Product Change Notice

PCN#: EE-PCN21003

XLR-48 and XLR-51 Mounting points

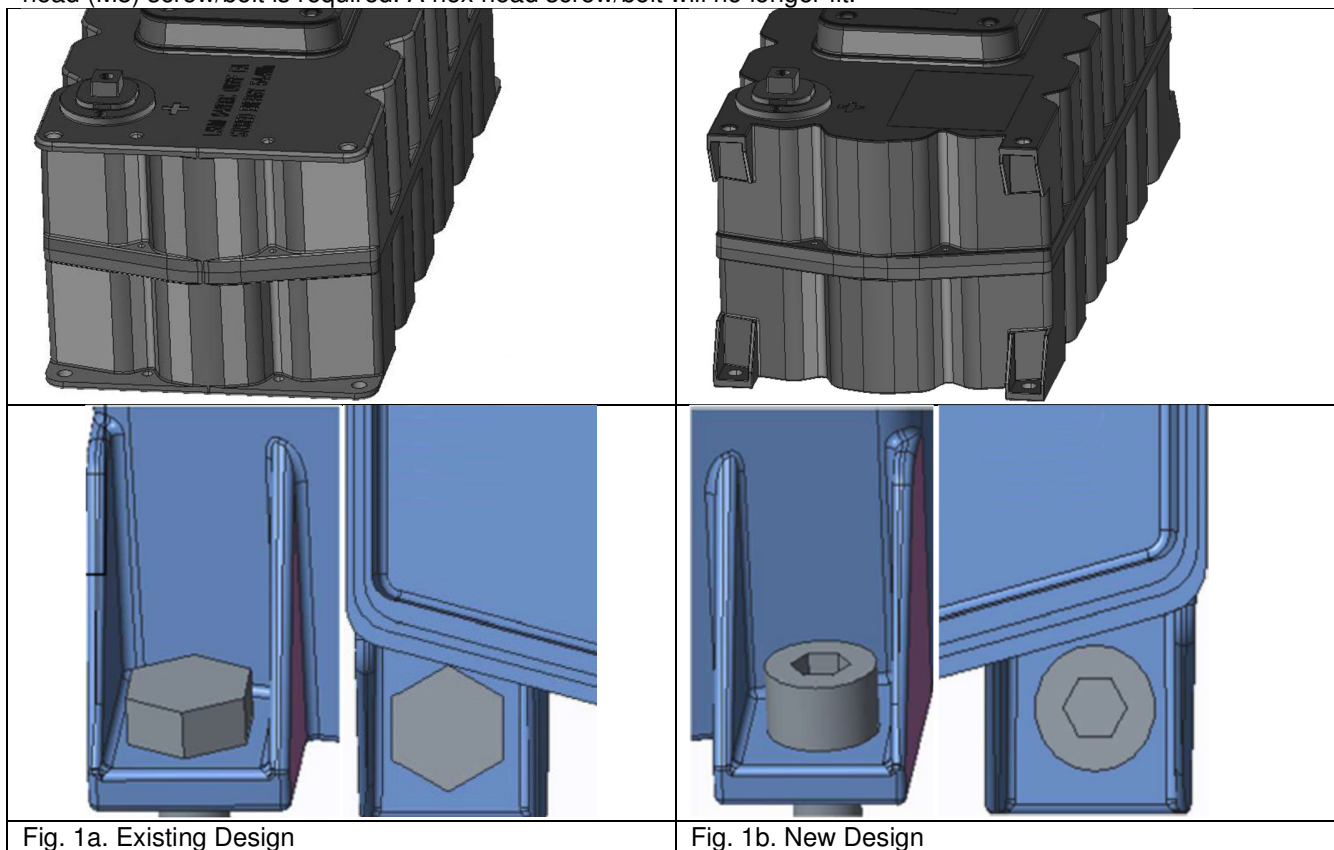
Corner mounting points are designed to increase strength and reduce accidental damage. Eliminate the need for a support spacer between the top and bottom plate. When using the bottom plate mounting holes only, a socket head (M8) screw/bolt is required. A hex head screw/bolt will no longer fit.

There is no change needed in the bolt when mounting through the top plate. However, a spacer is no longer needed.
